Ducted Systems Technical Services Service Letter

Letter: **YS-005-2018**

Subject: 16 SEER Heat Pump AOC Control Board Logic Error

Product: **Residential YHM, CH16 & TH16 16 SEER Heat Pumps**

Figure 2 – Reflashed Identifier

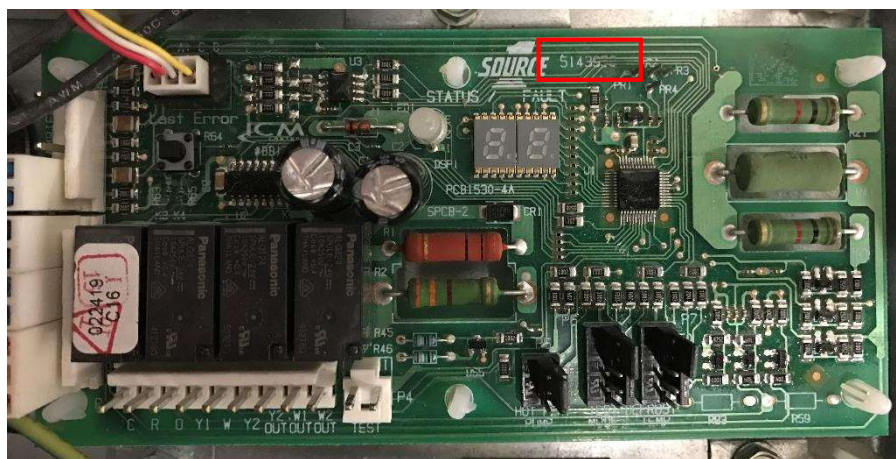
AOC control boards that contain the correct logic can be identified by software revision code that is placed on the CSA label shown in figure 2. Boards with the correct logic will note software version 1.01 on the label. The vendor is currently producing control boards for us with the new software logic and will indicate the software version on the CSA label has mentioned above; however, the SAP part number will still show as 5143958 (as shown in the red square of Figure 1). Eventually, the SAP part number will change to 5539148 which will be printed in the same location of the red square box in Figure 1. All of the control boards we had on hand in Source 1 inventory are being reflashed with the new software by the vendor and will also contain the CSA label indicating the software version 1.01.

Units installed in the field (that were produced prior to September 1, 2018 (W1K8 date code) should have the AOC control board replaced to prevent this nuisance fault. This service letter will allow one hour's labor time plus credit for the control board. Make sure the dealer references this YS letter when filing their claim.
